Application for Licence Amendment

Part V Division 3 of the *Environmental Protection Act 1986*

Licence Number	L9037/2017/1
Licence Holder	Mt Marion Lithium Management Pty Ltd
ACN	666 116 365
File Number	DER2017/000308-1
Premises	Mount Marion Lithium Project Shire of Coolgardie Mining tenements M15/1000, M15/717 and on private land known as Hamptons Lease Area 53, portion of Lot 105 on Deposited Plan 40396, Volume 2668 Folio 420. As defined by the Premises maps attached to the Revised Licence
Date of Report	28 August 2024
Decision	Revised licence granted

Figure 2: Examples of optimized tailing deposition into Ghost Crab pit

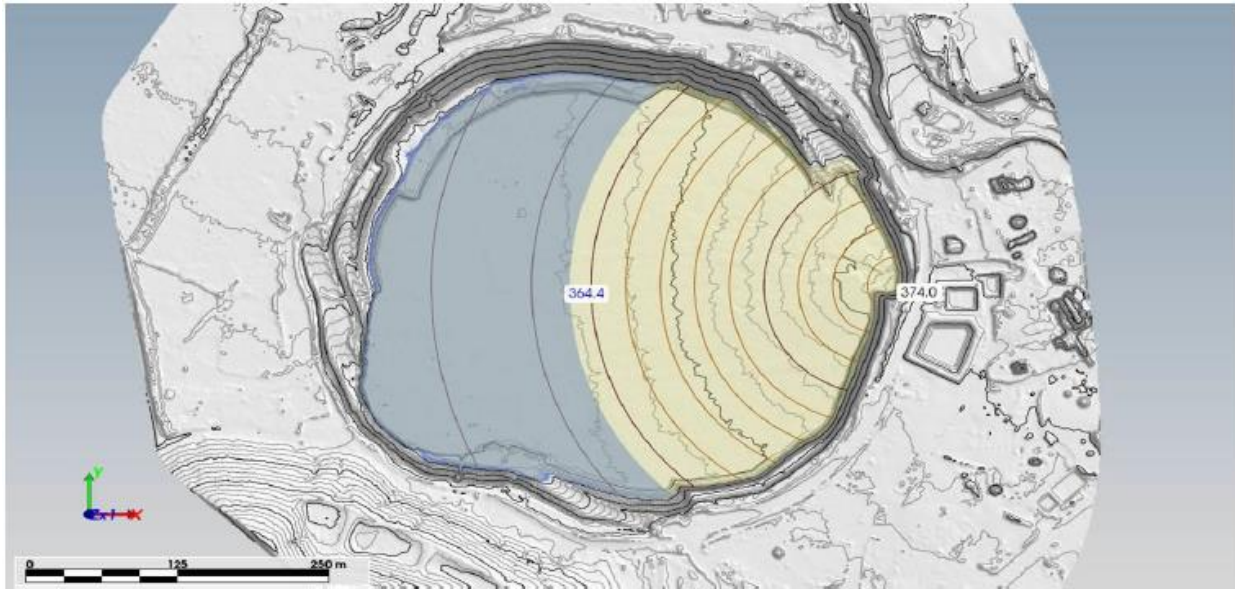
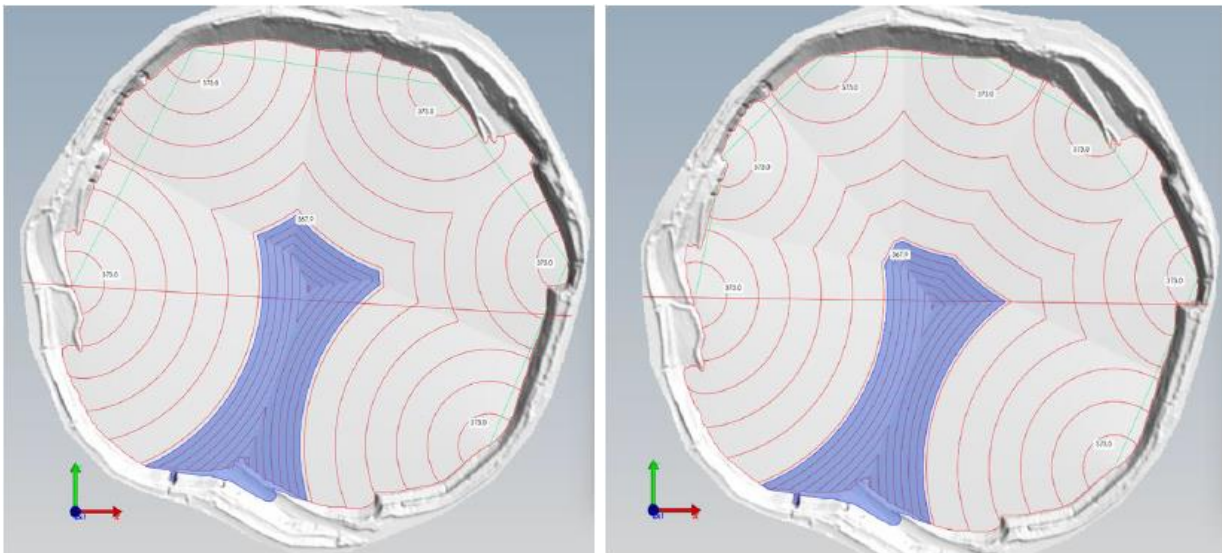
The licence holder commissioned modelling to determine the TSF rate of rise based on the current single deposition point arrangement (Figure 1) and a scenario involving multiple spigots (Figure 2).

Conditions in the current licence include the requirement for the TSF to maintain a 6 m freeboard, with the tailings level not exceeding the 374 mRL. Based on the current tailings deposition strategy the licence holder predicts that once the pit crest reached the 374 mRL, the centre of the pit would only be filled to the 364.4 mRL, with a steep beach leading up to the current discharge location.

The licence holder believes that the scenarios provided in Figure 2 demonstrate a more favourable outcome, allowing the outer perimeter of the TSF to reach the 374 mRL, providing approximately 660,000 m³ of additional tailings storage. The licence holder states that the proposed various arrangements of spigots will allow flexibility to enable the most appropriate locations for the spigots and pipeline extensions to be sited. This will not only maximise the

Figure 3: Indicative Ghost Crab in-pit TSF spigot arrangement

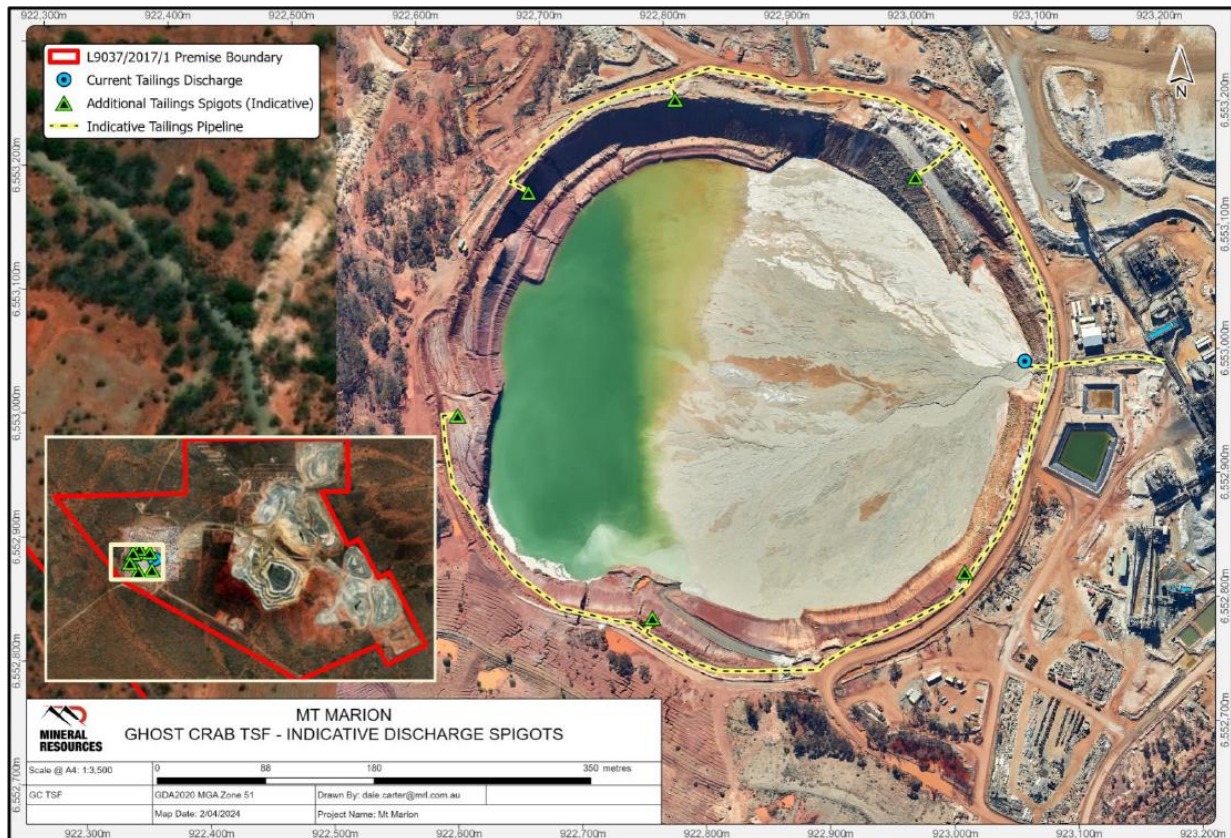
The discharge of tailings to Ghost Crab Pit was originally assessed under Works Approval W5732/2014/1. Tailings discharge occurs from a polyurethane pipeline and is deposited into the pit from the eastern crest (Figure 3).

Figure 4: WWTP location

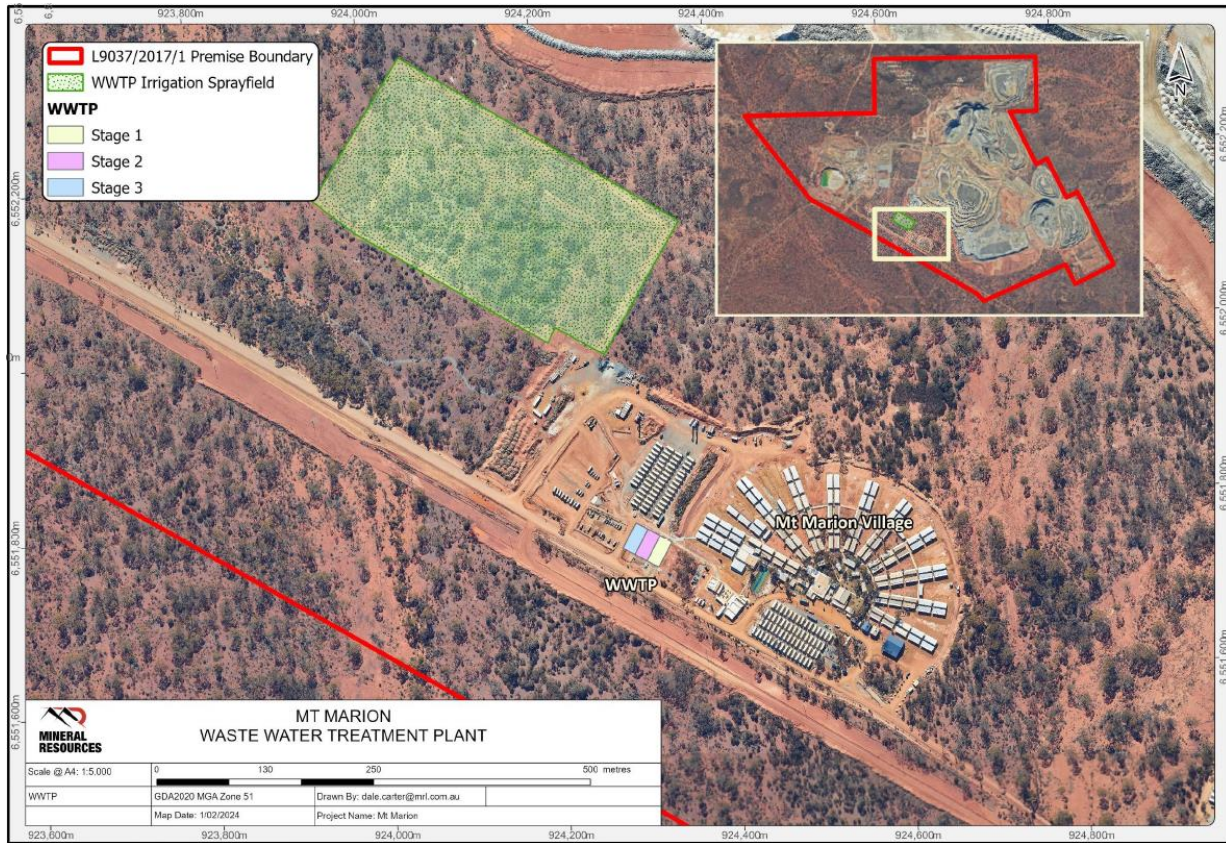
The site layout, showing the recently constructed Stage 2 and Stage 3 WWTP units, adjacent to the existing unit is below Figure 4.

Figure 5: As built arrangement of the WWTP

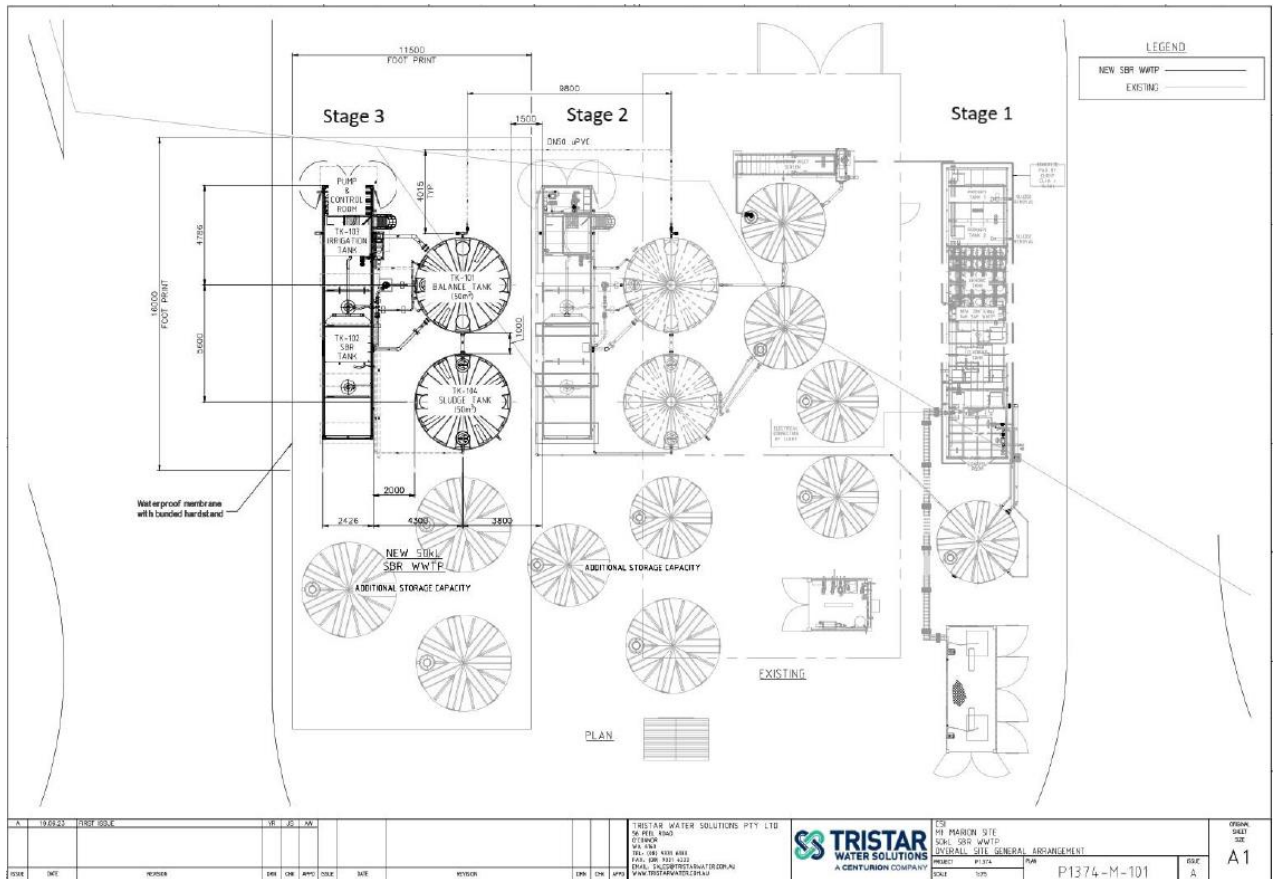
An as-built arrangement of the units is detailed in Figure 5.

Figure 6: WWTP irrigation spray field as built

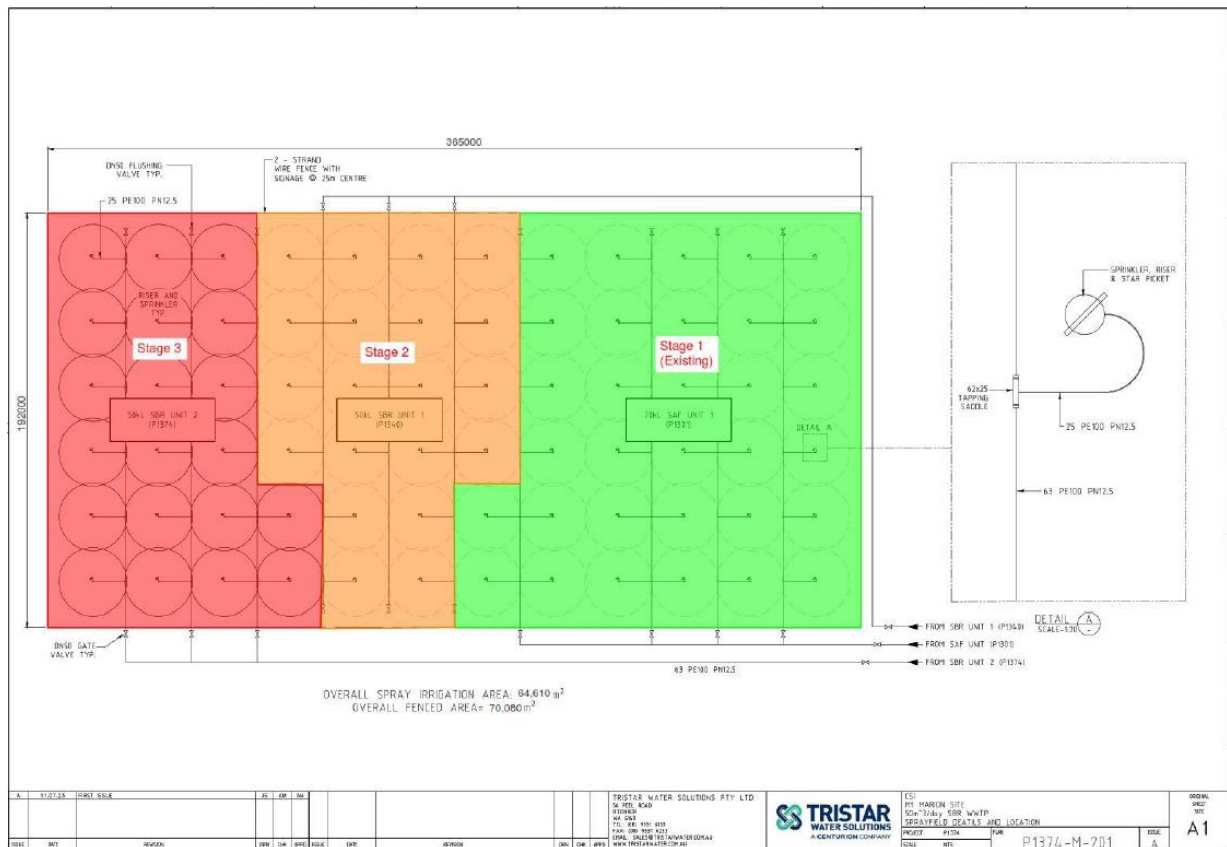
The existing spray field has been extended to a 7 ha fenced area, with a spray field footprint of 6.64 ha (Figure 6). The expected nutrient loading rates from the WWTP operating at 170 m³ a day is shown in

The irrigation field area is located over 500 metres away from any significant surface water bodies and consists of red loamy earth (75%), loamy gravel (20%) and calcareous loamy earth (5%), which is consistent with Eutrophication Risk Category D as described in Table 1 of Water Quality Protection Note (WQPN) 22 (2008).

The Delegated Officer used calculations from WQPN 22 to determine the minimum area required for effluent irrigation is 4.14 ha. Therefore, the licence holder’s 6.64 ha spray field is adequate to discharge 170 m³ per day.
